ECE/TRANS/WP.29/GRRF/2008/16  
7 July 2008

**REGULATION No. 55  
(Mechanical couplings)**

Proposal for draft amendments to Regulation No. 55

Submitted by the experts of the informal working group on mechanical couplings <sup>\*/</sup>

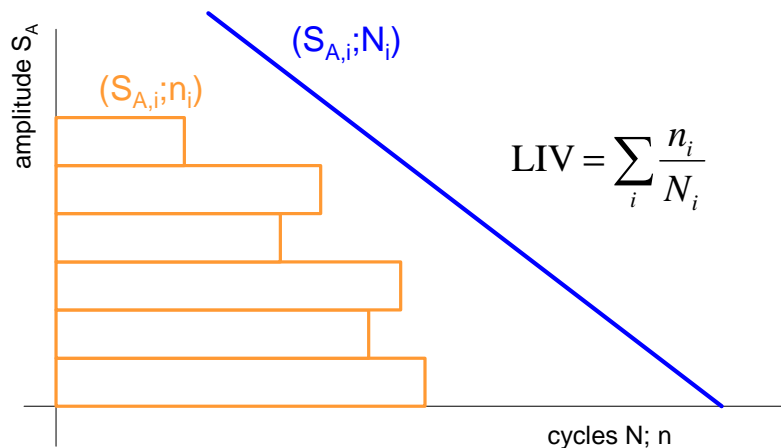
The endurance test described below consists of a multi-axial test with 3 load directions, with simultaneously introduced forces, defined maximum amplitudes and fatigue equivalences (load intensity values, according to the definition given below).

Figure 1

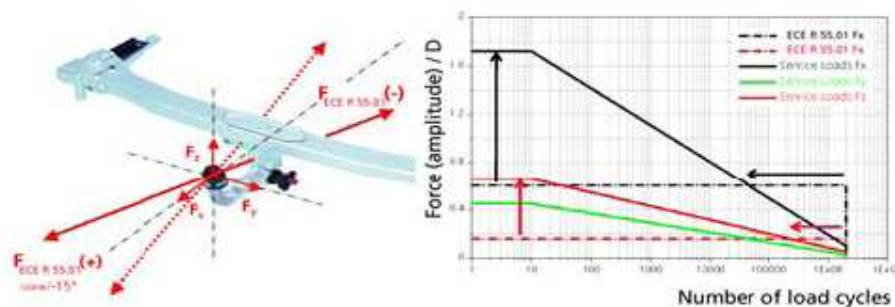
The graph in Figure 1 shows a comparison between the force amplitudes applied in the present fatigue verification test according to the Regulation No. 55, 01 series of amendments and the loading used by car manufacturers to represent customer service.

The procedure according to paragraph 3.1. of Annex 6 to Regulation No. 55 is an uni-axial test: 2-load cycles with constant amplitudes (definition see in Figure 1; the force components  $F_x$  (longitudinal) and  $F_z$  (vertical) are due to the chosen force direction, see the rectangular spectra in Figure 1. Lateral forces are not taken into account.

Figure 2: Evaluation of real service loads due to different car manufacturers.

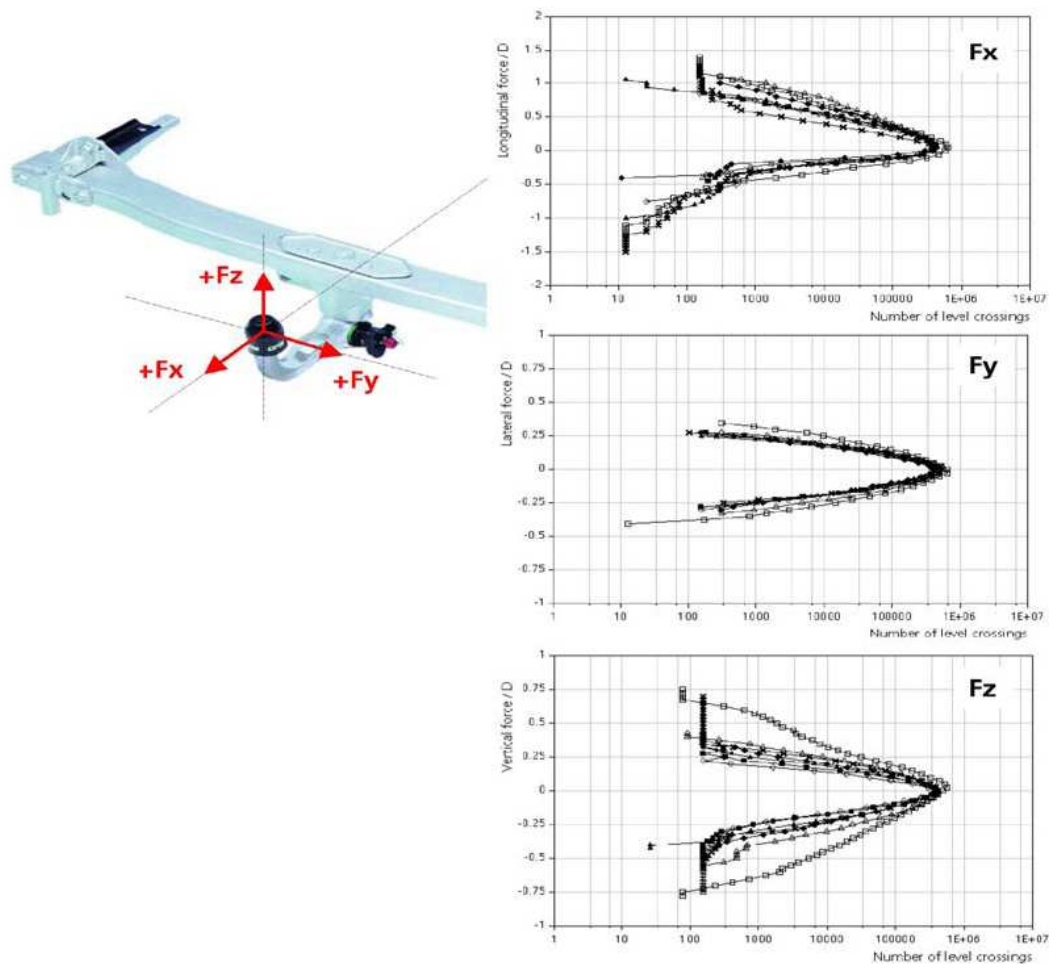
The service loads, measured from different car manufacturers on public roads and proving grounds with various vehicle-trailer combinations are, of course, subject to wide scatter, even scaled to the respective D-values, see Figure 2.

The causes are different driving and courses, special loading events, system characteristics and the car-manufacturer-specific verification philosophies behind it.

Figure 3: Comparison of equivalent amplitudes - Fatigue verification tests according to Regulation No. 55, 01 series of amendments (42 verification tests, damage sum supposed for constant amplitude = 0.3)

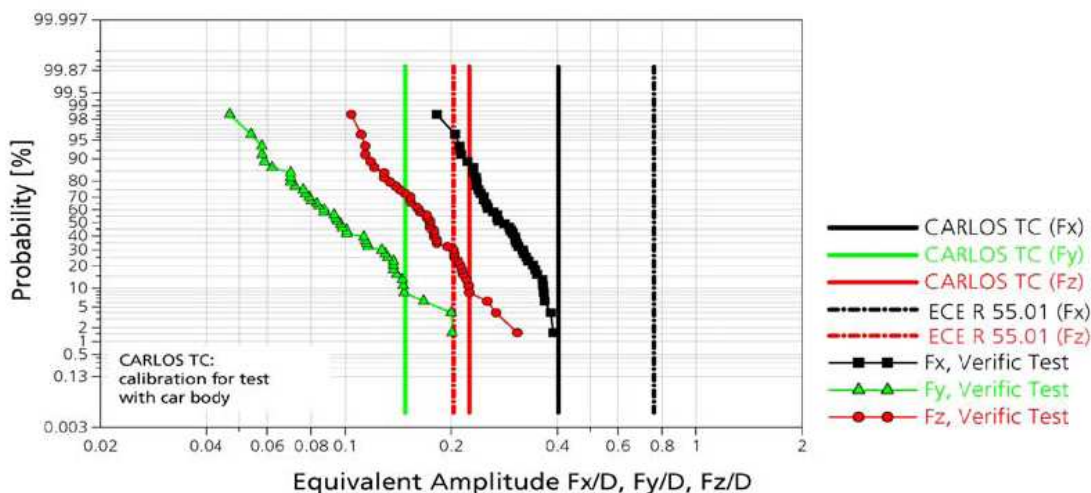
The damage-equivalent amplitudes of the 3-dimensional test load intensity orientated test procedure match the loading distributions of the car manufacturers used for verification testing with well defined probabilities of exceedance (see Figure 3).
